DRAINAGE REVIEW:

Berwick Health and Education Precinct
for
Victorian Planning Authority

April 2017

Figure 6. Waterway corridor alignment and culvert extension

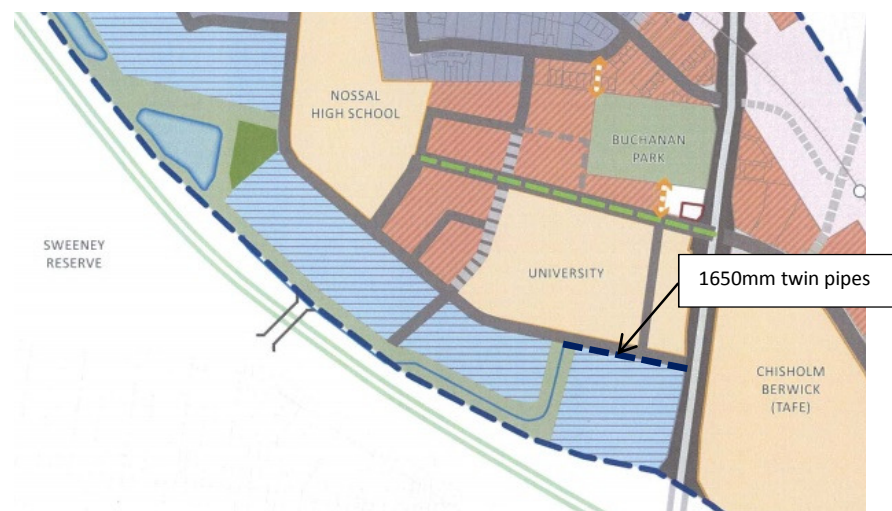
The alignment of the constructed waterway generally follows the waterway corridor as shown on the Future Urban Structure Plan. The plan should be amended to show the constructed waterway corridor commencing at the boundary of the east-west collector road (see Figure 6).

Figure 7 Typical-section for the constructed waterway

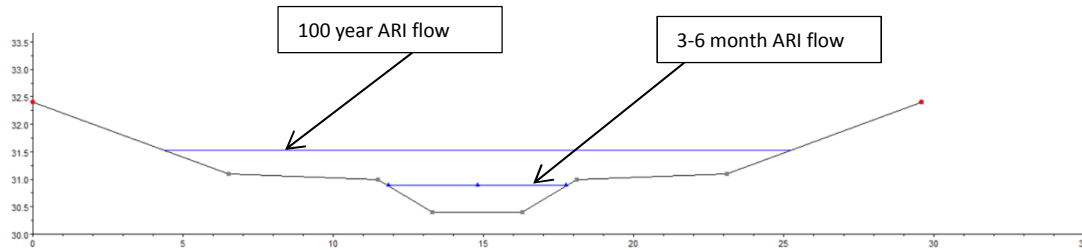
The low flow meandering channel is 0.6 m deep, with a base of 3 metres and slopes of 1 (V) : 3 (H). The low flow channel is to meander across the 13 metre base. It has a capacity of around 2 m³/s, which is approximately a 3- 6 month ARI design flow. The high flow channel has the capacity of the 100 year ARI event (ie 13 cumecs).

In order to convey these flows and remain within the waterway corridor, a typical cross-section depicted in Figure 7 will be used.

Figure 9 Option 1 – culvert extension

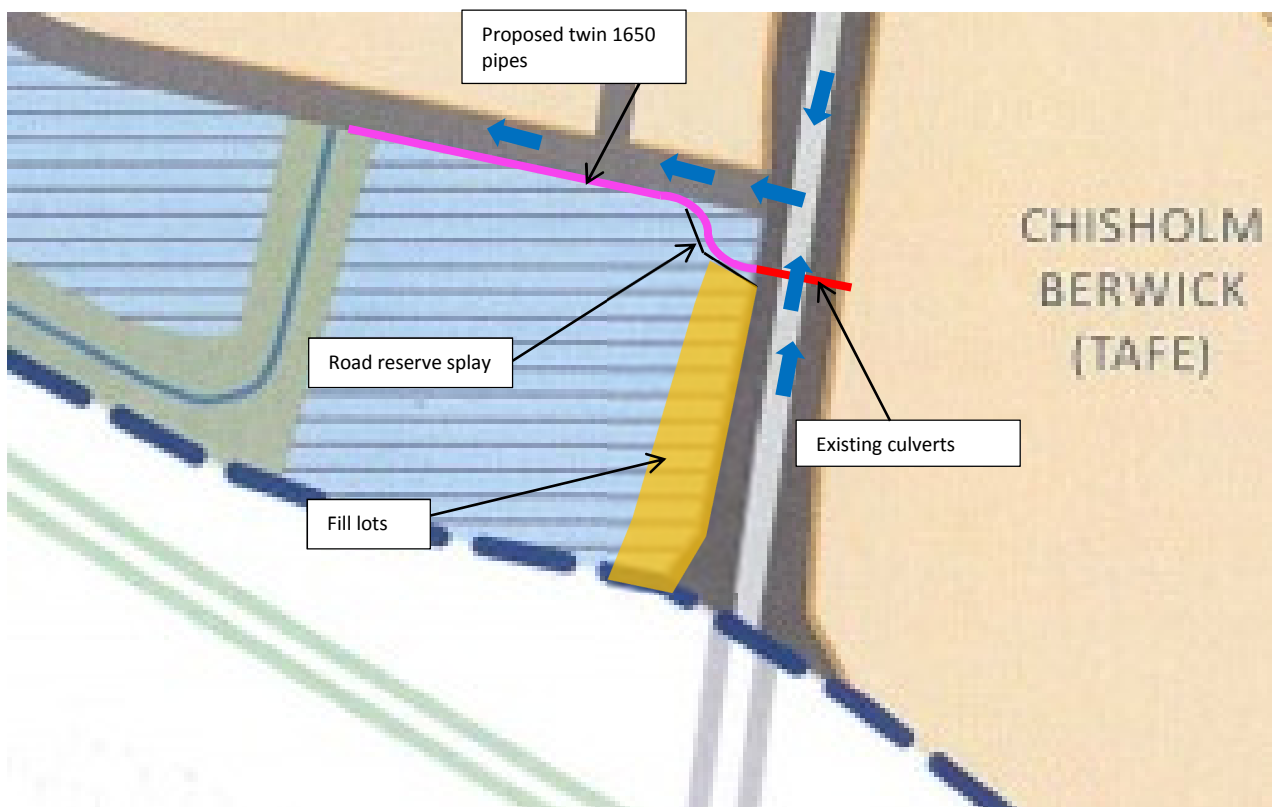
Due to the size and hydraulic operation of the 100 year ARI culverts/pipes, it is not appropriate to have two right angle bends in the pipe in order to follow the proposed alignments. The east-west road will need to have an extended splay on the south side of the road reserve to accommodate the curve and bend in the pipe system. The minimum radius for the curve in the pipe would be about 14 metres. The future SWMS to be prepared for the site will provide the functional details of the road reserve and splay layout to accommodate the necessary curved pipe radius for the 1 in 100 year ARI pipes. This will include the functional hydraulic design of the pipe, which incorporates an allowance for losses (eg bends).

Whilst the culvert/pipe would be designed to carry the 100 year ARI design flows, it is good floodplain management practice to provide an auxiliary overland flow path. This auxiliary flow path could be provided by the proposed east-west road. The current crown of Clyde Road at the low point appears to be relatively broad (approx RL 39.5m – this needs to be confirmed by survey). Therefore the proposed commercial development should be filled a minimum of 600mm above the Clyde Road crown at the east-west intersection to enable any auxiliary overland flows to “funnel” down the east-west road.

From a safety perspective, it is likely that the inlet on the existing culverts may need to prevent public access through the use of a grill or cage type structure.
